NEW RIVER CENTRAL

DEVELOPMENT REVIEW COMMITTEE (DRC)

DEVELOPMENT REVIEW COMMITTEE (DRC) COMMENT REPORT

Request: Site Plan Level II Review: 408 Multifamily Units and 5697sf of Retail Use

2 NORTH ELEVATION
A109 1"=20'-0"

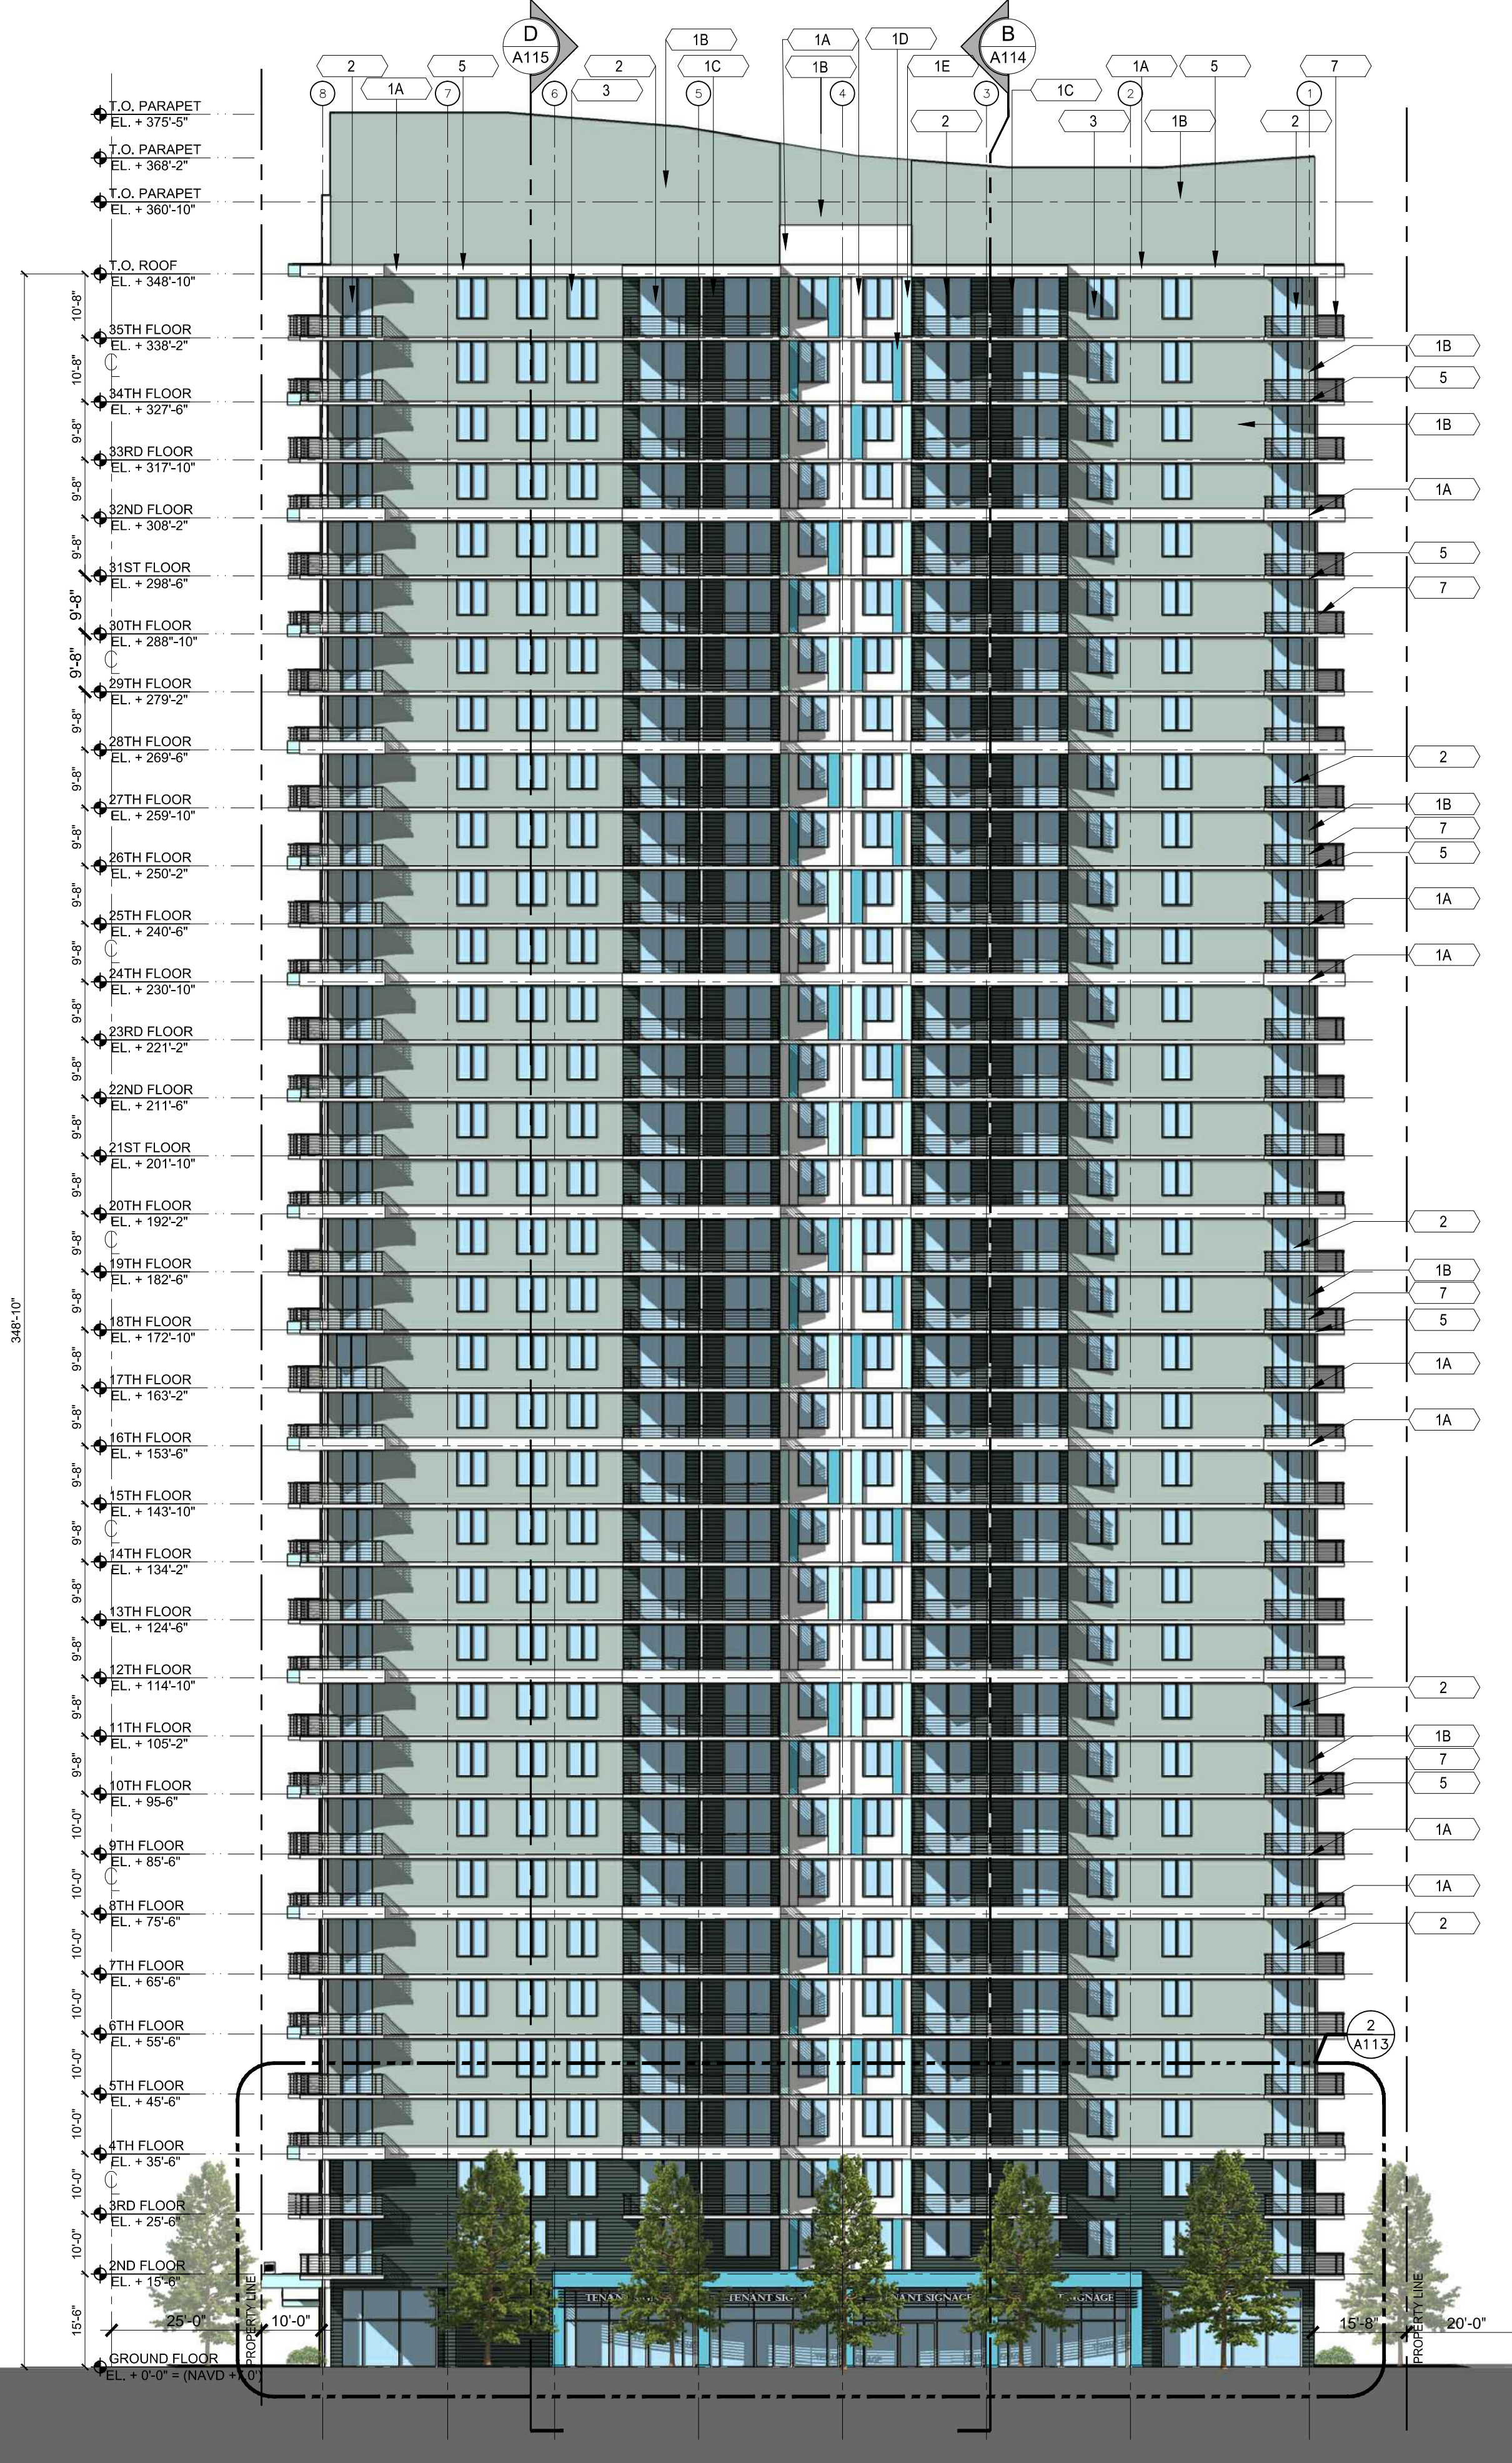
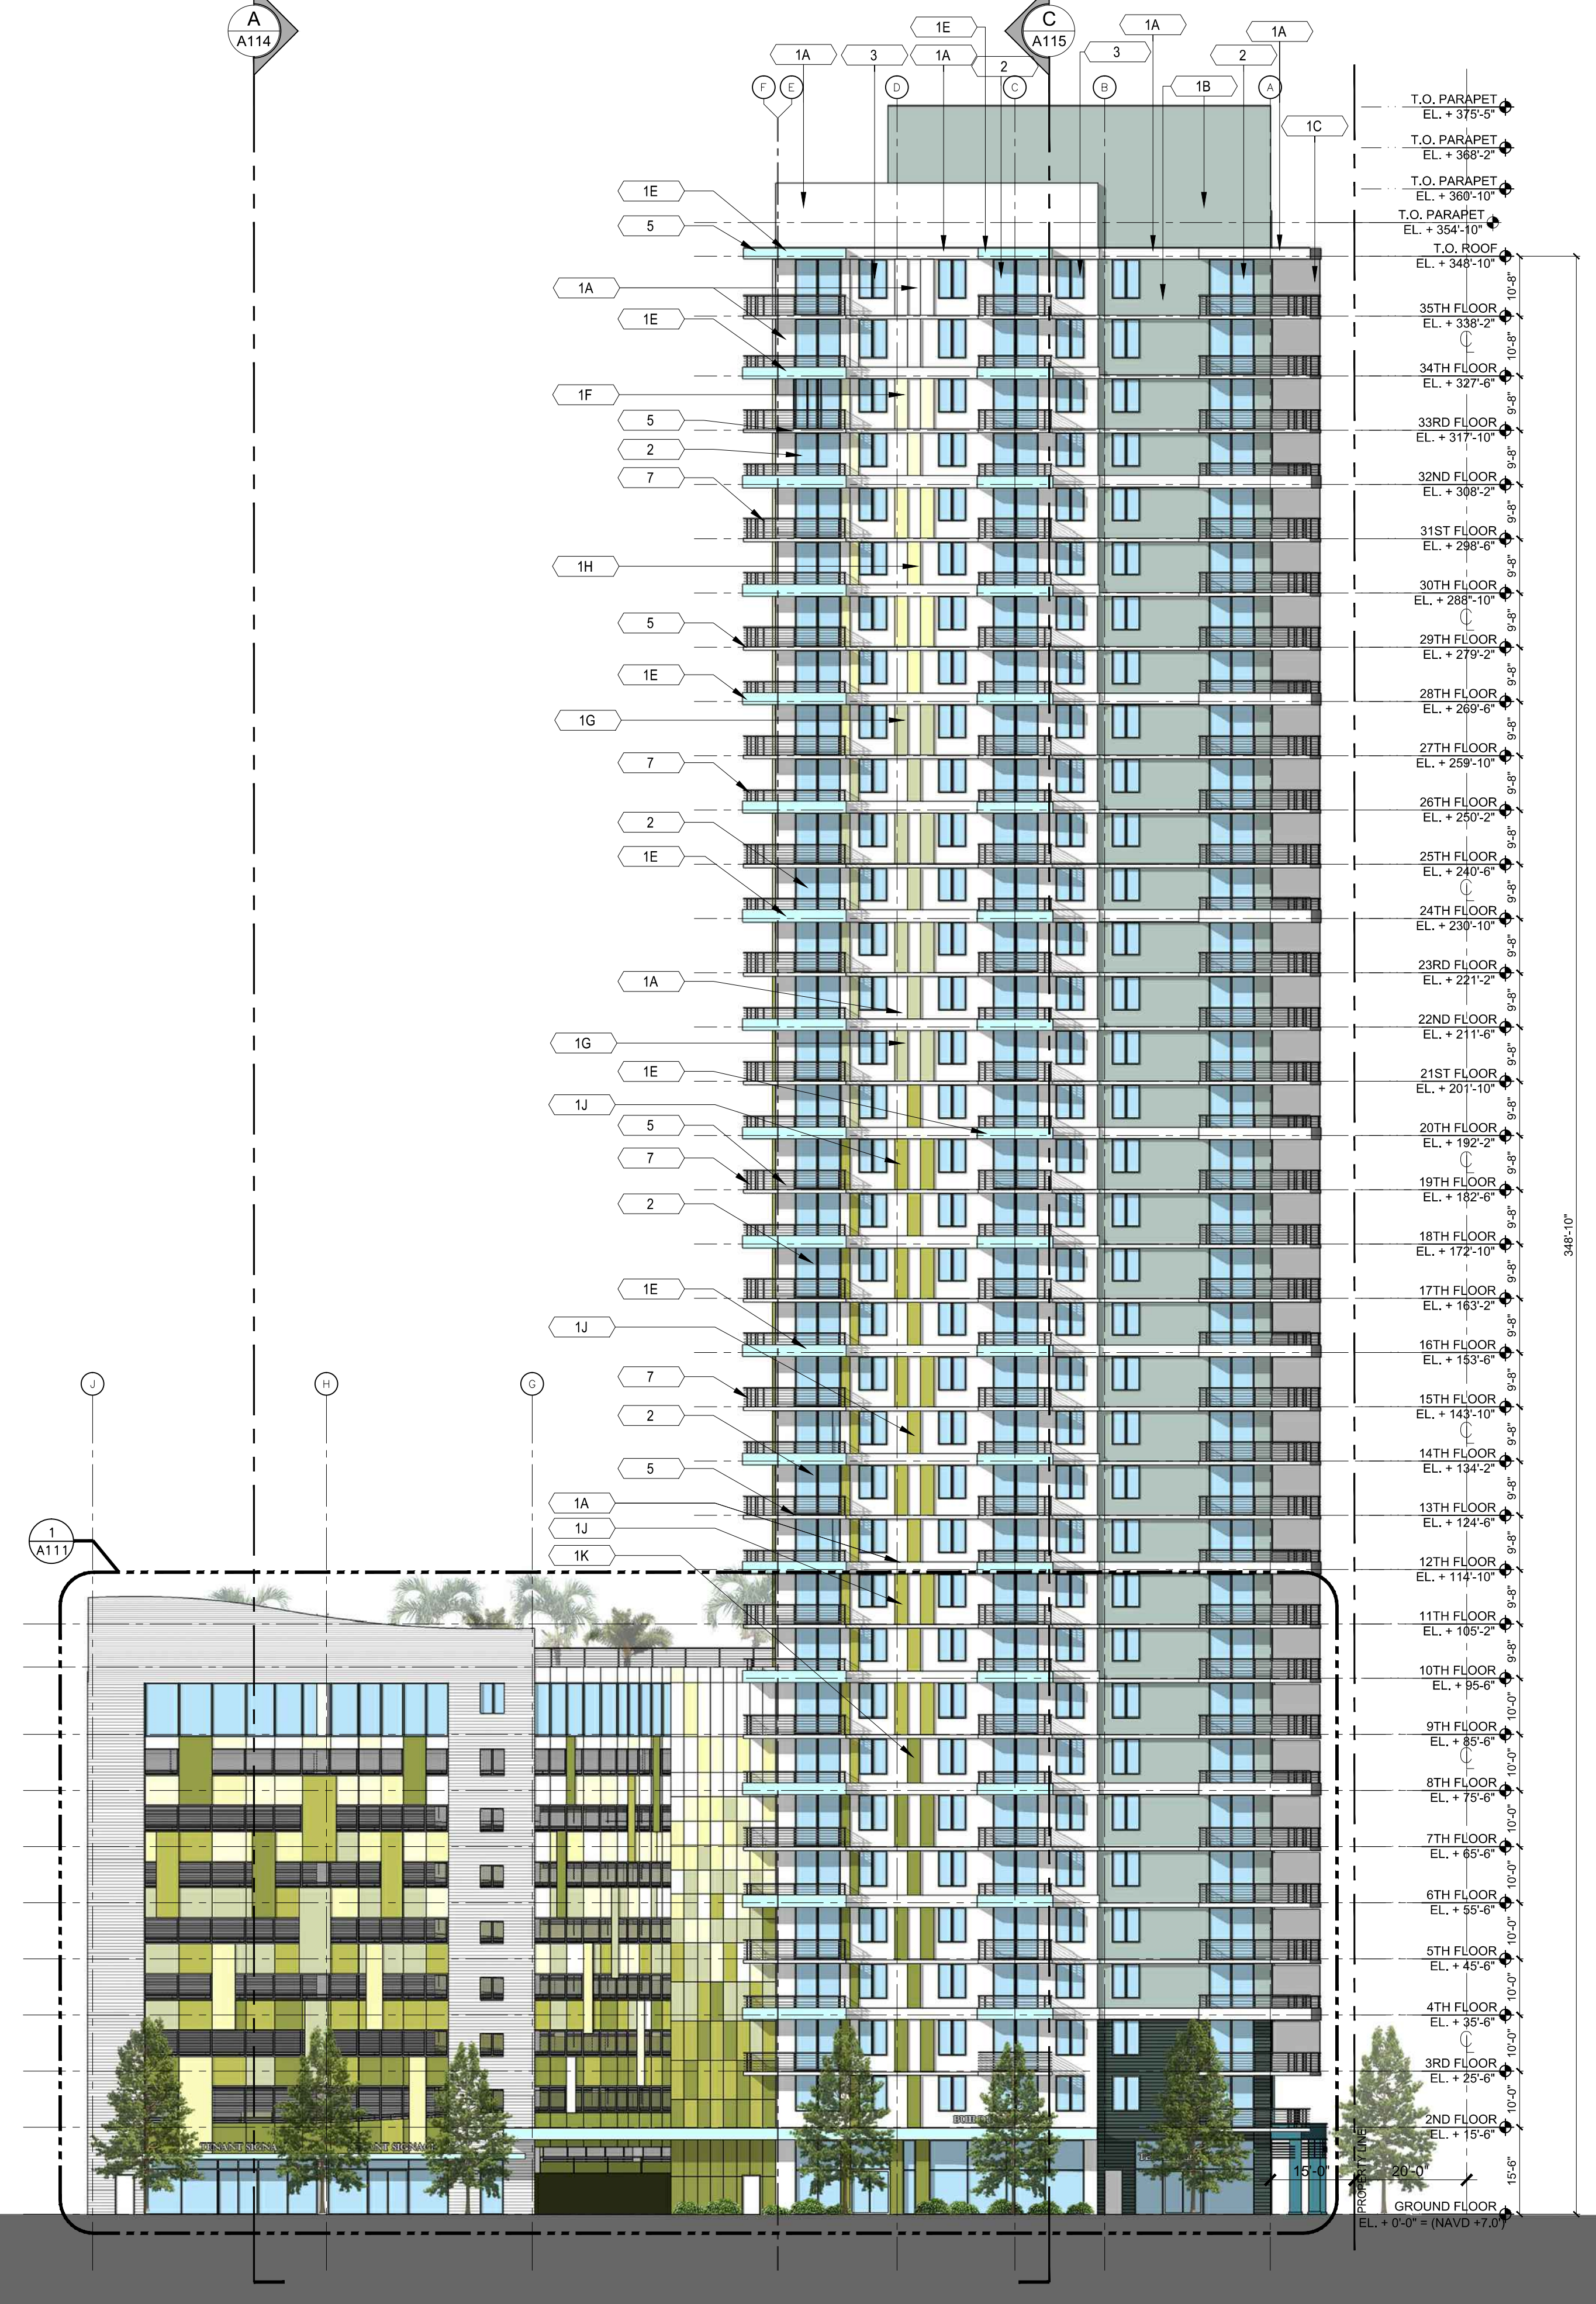
5. Sheet A109 thru Sheet A116 – Verify that building overhangs shown over public sidewalk access, along S.W. 6th Street and S.W. 1st Avenue sides of the proposed development, are consistent. In addition to

15. Show and callout delineations for proposed Sidewalk Easement boundaries on the Site Plan and the Civil drawings. On Sheet A109 thru Sheet A116 (8 Sheets), show and label existing Right-of-Way, and proposed Sidewalk Easement boundaries on all building elevation details.
